ADDENDUM NO. 01

PROJECT: WCS – Hunt HS – Athletics Renovation

CPL PROJECT NO. R22.16900.00

DATE: 10.16.2023

Drawing Number: L100

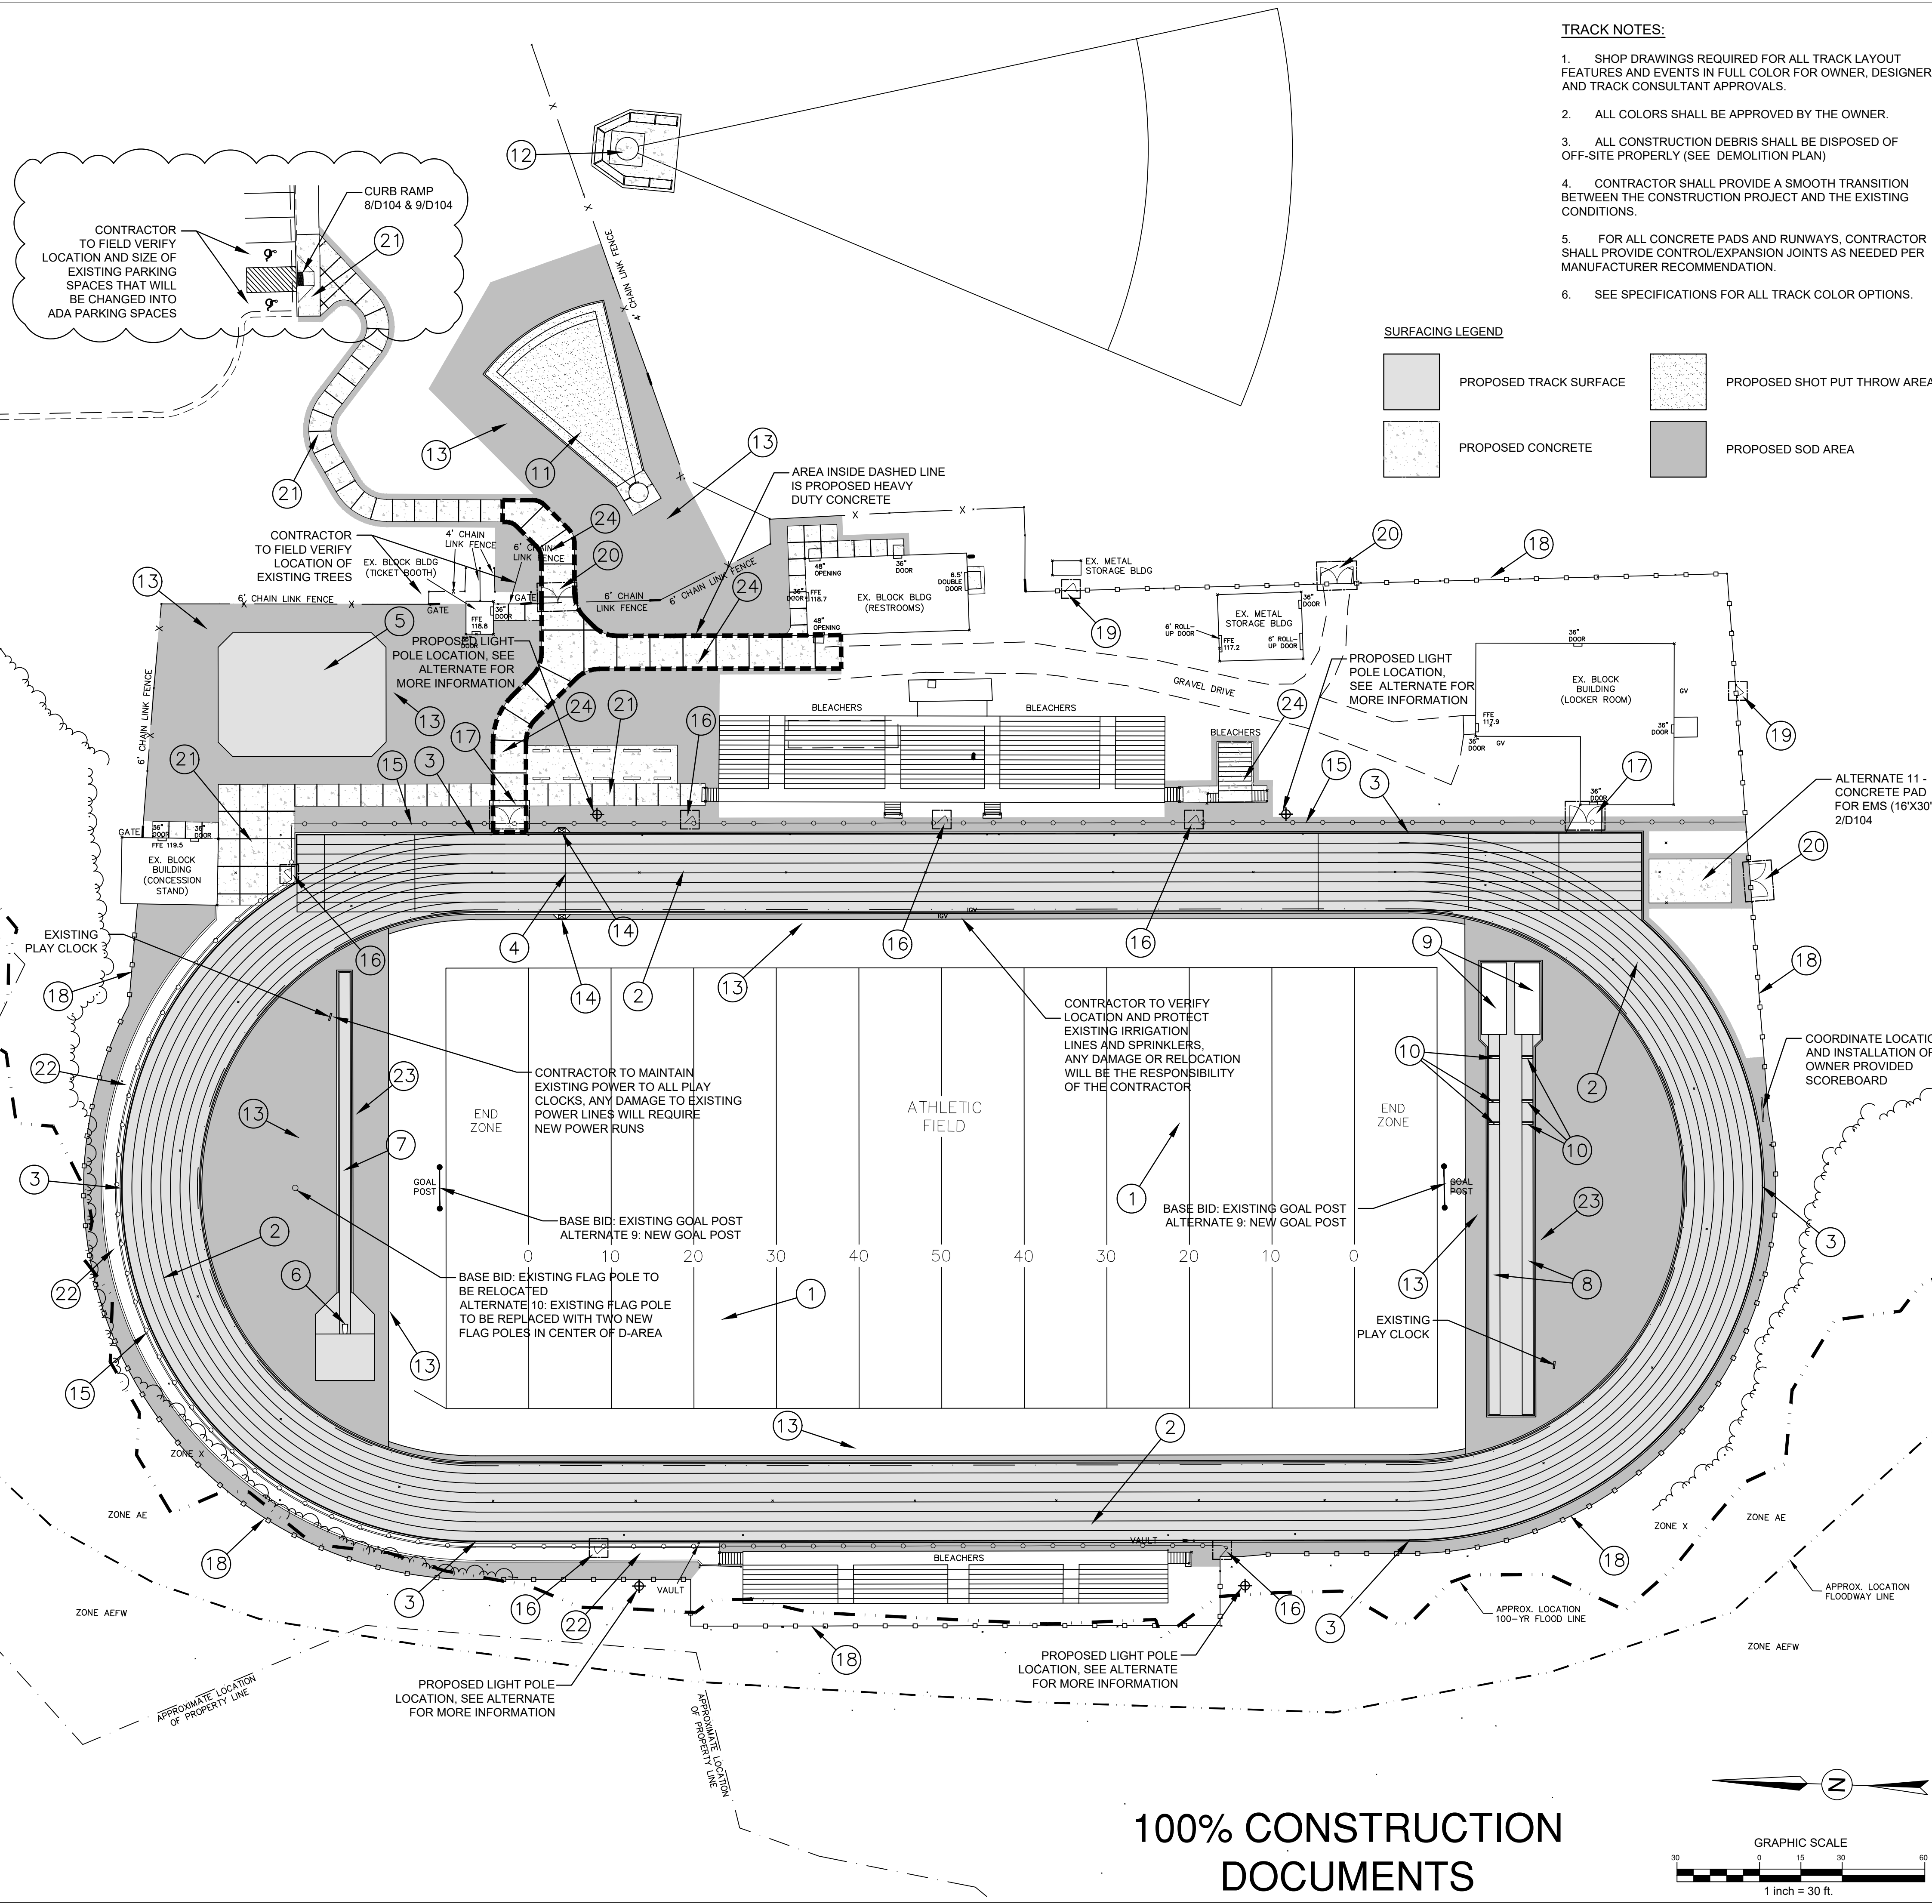
L100 – Layout Plan

Updated to show two (2) ADA parking spaces.

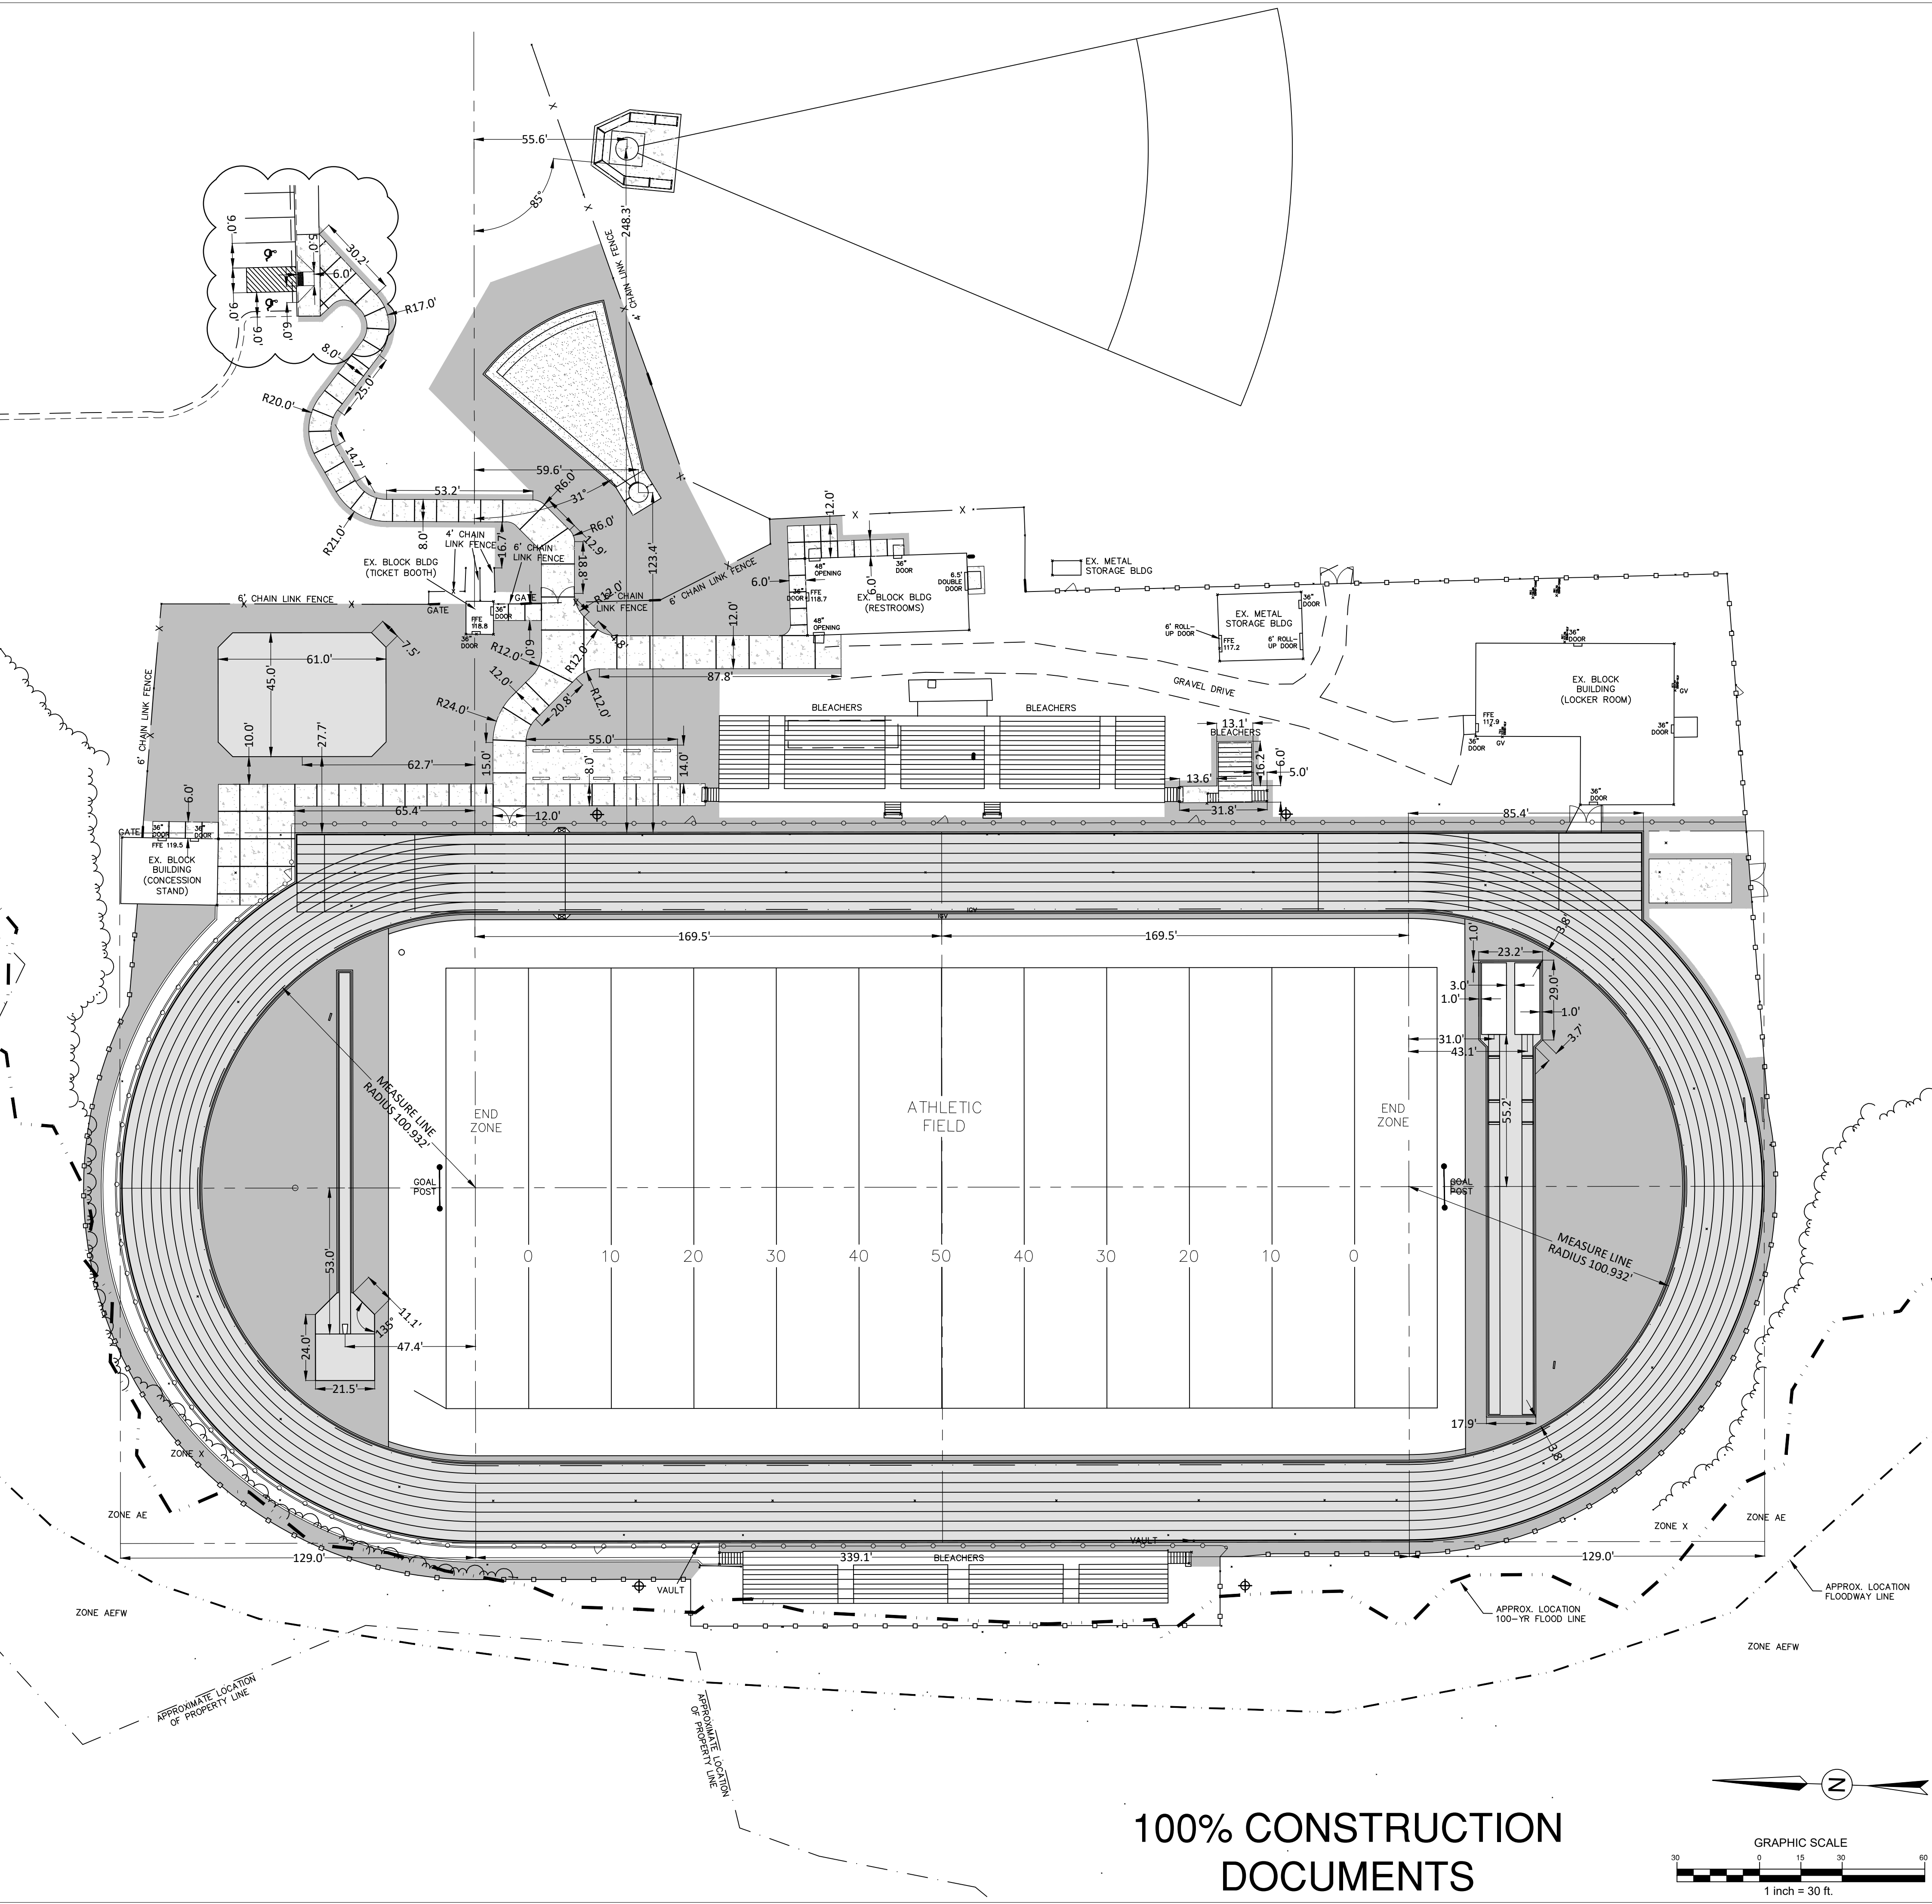
L101 – Dimension Plan

Updated to show two (2) ADA parking spaces.

2 CONCESSIONS BUILDING FLOOR PLAN
1/4" = 1'-0"
TRUE NORTH

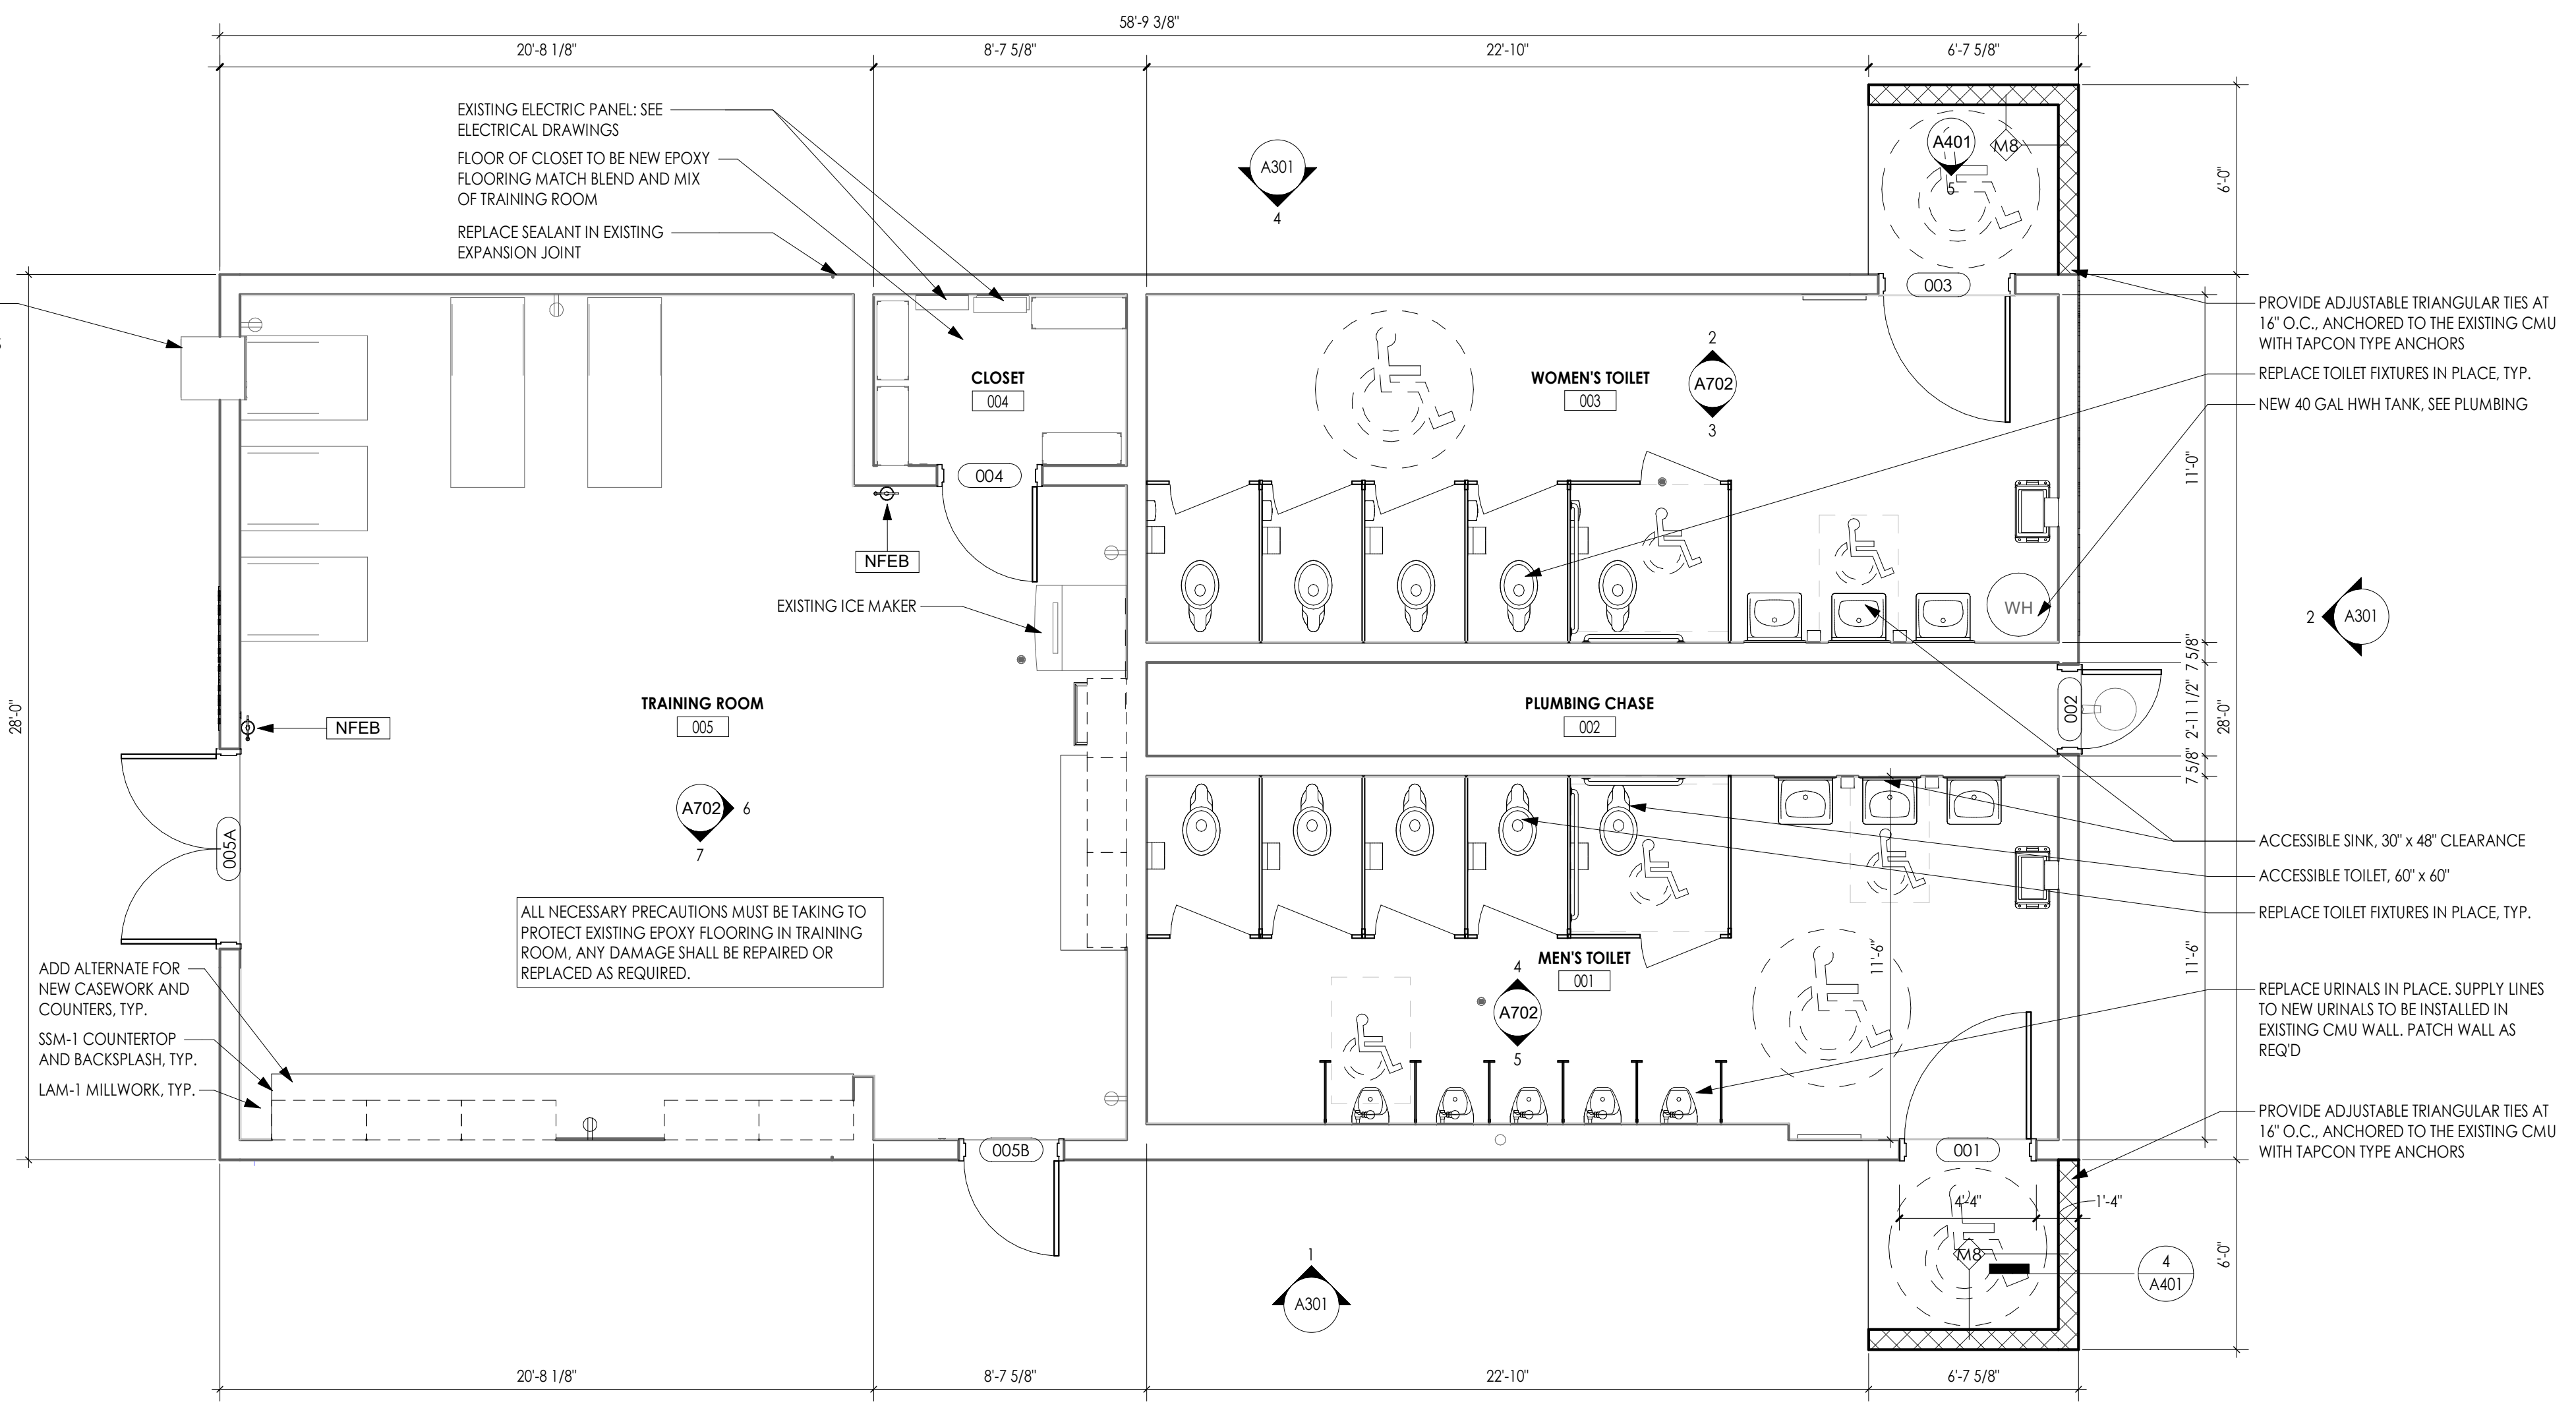
A101 – Overall Floor Plans

Updated notes to clarify: the storage shelving units each have 5 shelves, the size of the access door in 104 & the new fire extinguishers in the concessions.
